Work Order ID 136722

Item Name: Quick Release Heli-Utility-Basket™ Long, Light Lid, Spacepod™/Squirrel Cheek Comp

DART SERVICE INSTRUCTION

TO AMEND INSTALLATION INSTRUCTIONS D350-607-3 Rev.D,
INSTALLATION INSTRUCTIONS D350-607-4 Rev. C AND
INSTRUCTIONS FOR CONTINUED AIRWORTHINESS ICA-D350-607 REV. 6

FIGURE 1: INSTALLATION OF D4775-041 FWD STRUT

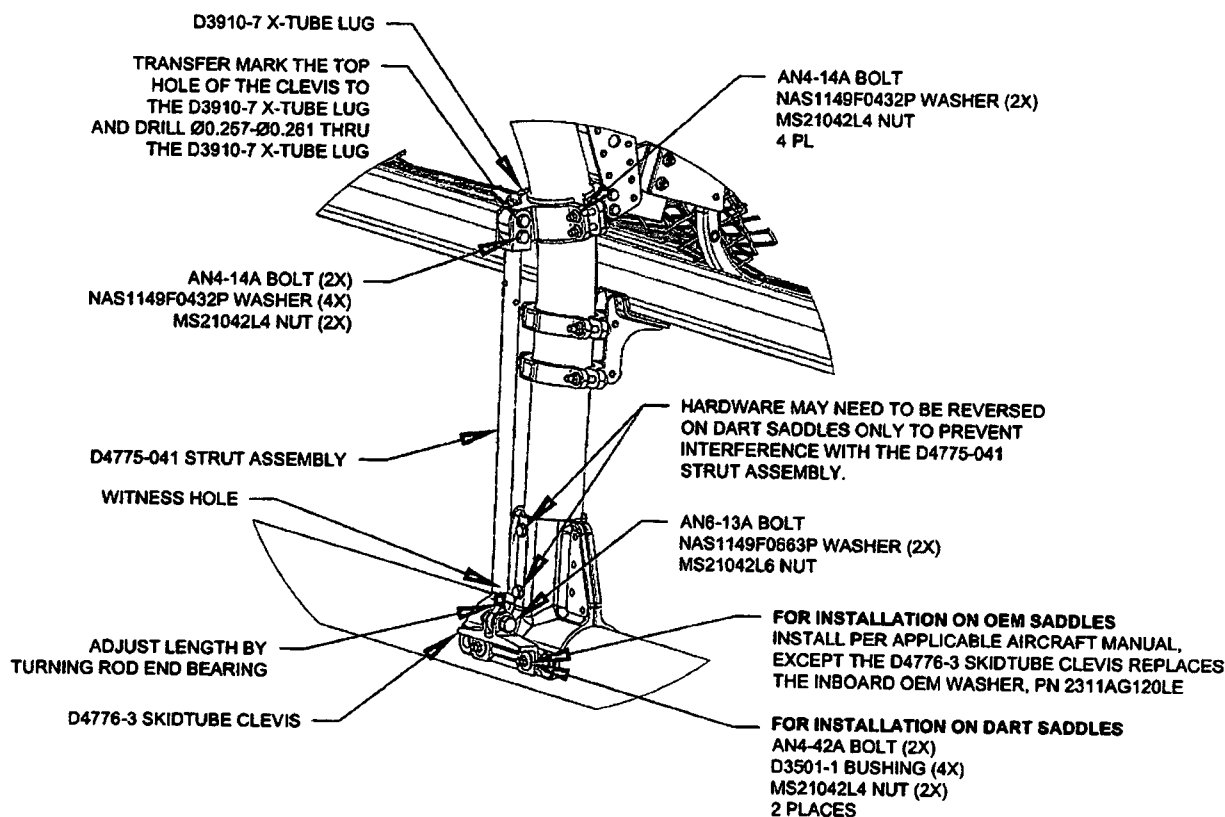
- 3.1 Substitute the Forward Lower D3910-5 X-Tube Lug with the D3910-7 X-Tube Lug as shown in Figure 1.
- 3.2 Install the forward D4775-041 Strut Assembly. Transfer mark from the upper hole on the clevis of the D4775-041 Strut Assembly to the D3910-7 X-tube Lug and drill thru the lug $\varnothing 0.257$ - $\varnothing 0.261$ as shown in Figure 1. Touch up chemical conversion coating per MIL-DTL-5541. Check the witness holes located at the bottom end of the D4775-041 Strut Assemblies to ensure that the thread from the rod end extends past the witness hole.
Torque MS21042L4/-4 nuts to 50-70 in-lbs (5.7-7.9 N-m). Torque MS21042L6/-6 nuts to 160-190 in-lbs (18.1-21.5 N-m).
- 3.3 Complete the installation in accordance with Installation Instructions D350-607-3 Rev. D or D350-607-4 Rev. C.
